MASSACHUSETTS INSTITUTE OF TECHNOLOGY

September 21, 1979

Mr. Howard A. Levin
Systematic Evaluation Program Branch
Division of Operating Reactors
Nuclear Regulatory Commission
Washington, D.C. 20555

The following is my comment on DELTA's response to Tasks 1 through 4, and my impression of the September 18th meeting.

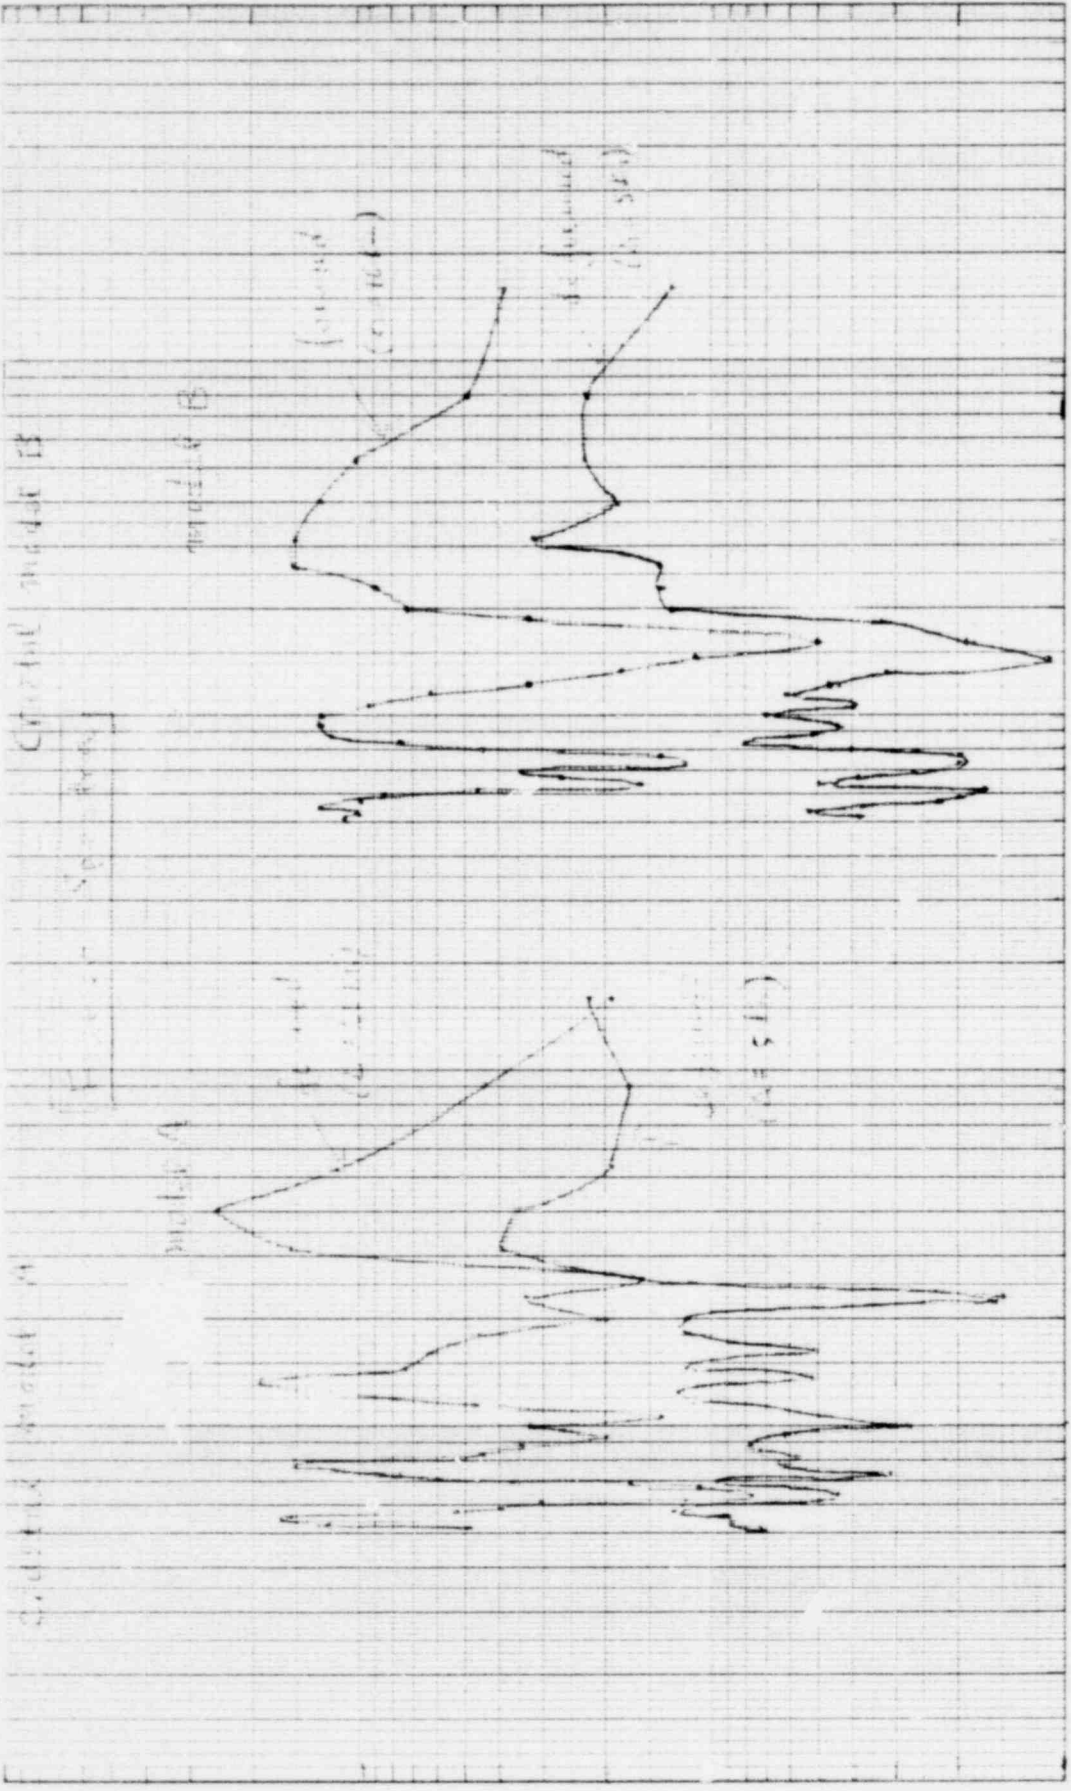
Observation points are at 5 km distance backward from the starting point of fault [Fig. 2.18], and at 10 km distance forward from the end point of fault [Fig. 2.19]. We calculated the Fourier spectra (for two crustal models simulating the structure under San Onofre) and compared them with the Response Spectra calculated by DELTA as shown in Fig. 1.

Considering the difference of Fourier vs. Response Spectra, and the difference in details of velocity profile, the agreement between Bouchon's and DELTA's results is satisfactory. For example, the spectral shape and the relative amplitude between forward (focused) and backward (defocused) stations are quite similar.

This agreement is encouraging, but may be somewhat fortuitous, because the rupture velocity is taken very close to shear velocity in all the DELTA models. My major question here is "do we still get a good agreement when the rupture velocity becomes lower and shock waves will have significantly different horizontal phase velocity from shear velocity?"
